Engineering Infrastructure Report

Crestwood Estate - Corner Rockhampton - Yeppoon Road & Norman Road, Norman Gardens

Residential Development - Stages 3B, 9, 10A, 10B and 11 (80 Lots)

Response to Information Request D-1647/2007

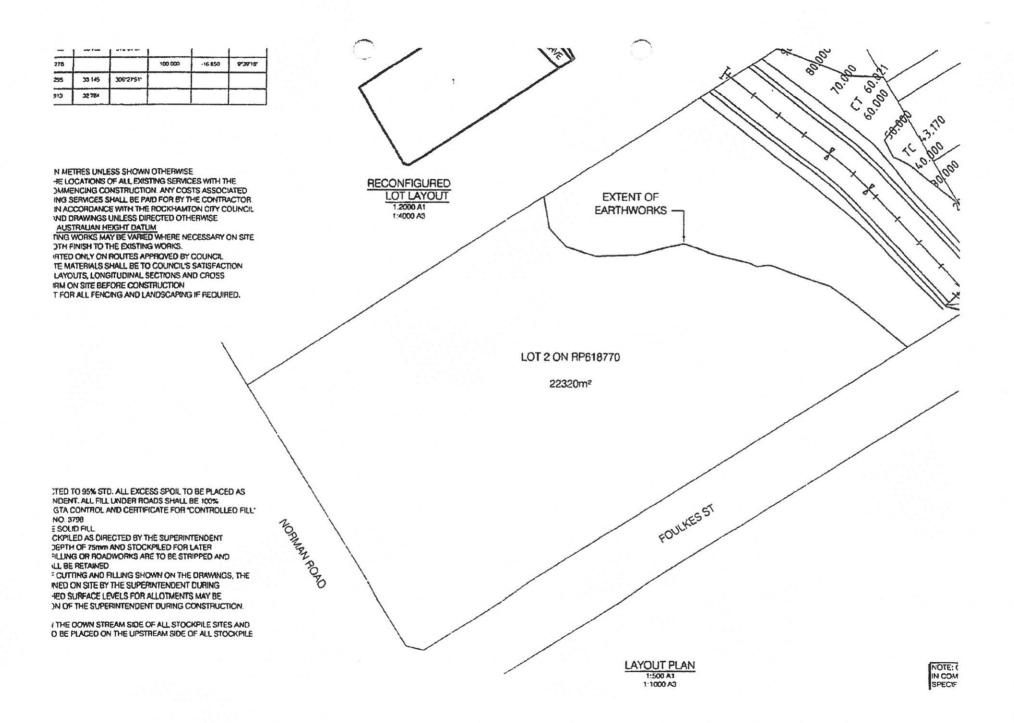
The proposed drainage easement in favour of Council shown on Drawing 439101-153-007(A) needs to be a minimum of 3 metres wide in lieu of 2 metres shown in order to comply with the requirements of the Capricorn Municipal Development Guidelines. Please amend the proposal plans accordingly.

The proposed access to the base of the drainage channel shown on Drawing 439101-153-007(A) appears to be located in an area where the batter slopes exceed those suitable for practical access to be achievable. Furthermore, the fencing associated with the culvert structure appears to conflict with the proposed location of the maintenance access. Therefore, the proposed maintenance access from Foulkes Street to the Drainage Reserve is not acceptable due to its proximity to the existing culvert structure and associated end structures, wingwalls, fencing and batter slopes. Please provide an alternative acceptable solution shown on a suitably scaled and adequately dimensioned plan. In addition, please identify all existing service infrastructure located on the road verge or in the vicinity of the proposed access. The proposed access to the Drainage Reserve needs to be suitable for heavy earthmoving equipment such as a 12 tonne excavator and, as a minimum, a Heavy Rigid Vehicle (HRV) as defined in AS2890.2-2002. Please demonstrate that the proposed access provides suitable access to the floor of the proposed channel and the culvert structure for the aforementioned maintenance machinery.

The drainage easement has been amended to provide the required 3m width. This is shown in amended Dwg. 439101-153-007 Rev B attached in Appendix A.

An "Amendment to Application" resulting from an RFI Response will be submitted to Council to include the downstream lot in the current application, with the downstream landowner's endorsement. This will allow Council to have legal access to the drainage reserve from the lot to the north, a general arrangement of which is shown on Dwg. 439-101-153-001 Rev B attached in Appendix A.

CHANNEL LONGITUDINAL SECTION

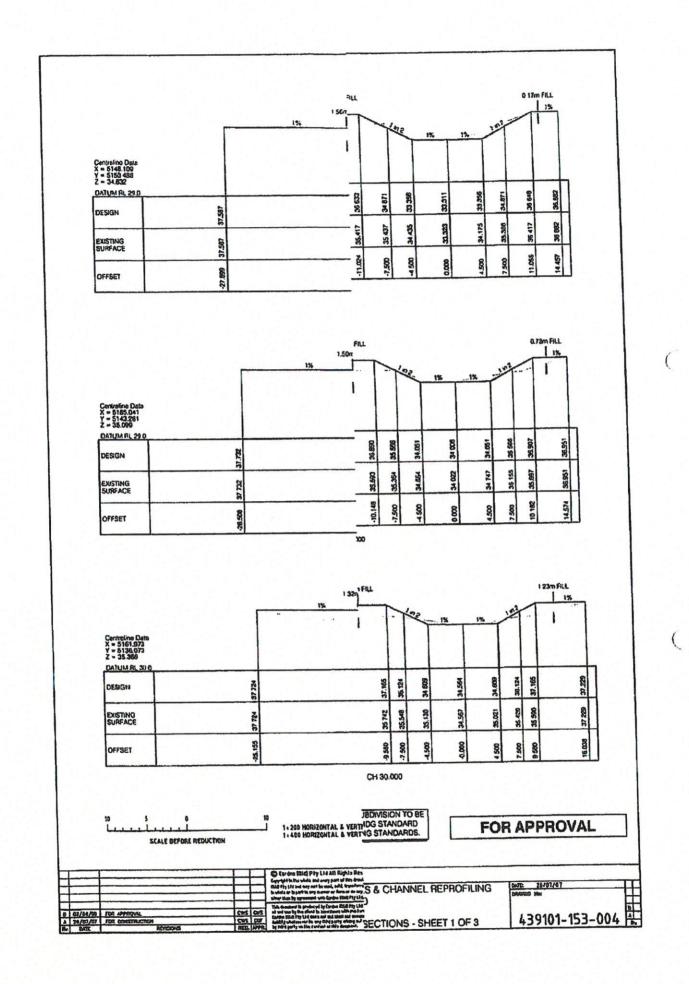
In relation to the proposed filling and excavation activity on the site please provide information to demonstrate that the excavation or filling will not adversely affect the amenity of adjoining or nearby properties in accordance with Performance Criteria P2 of the Filling or Excavation Code. This assessment should address the following matters:

- (c) the proposed channel longitudinal section shown in Dwg. 439101-153-003 attached in Appendix A, shows that there is to be no ponding within the site due to a constant grade to the north. This drawing also shows that the invert of the channel ties into the natural surface at the northern boundary of the subject site, therefore avoiding any ponding within the adjacent site to the north.
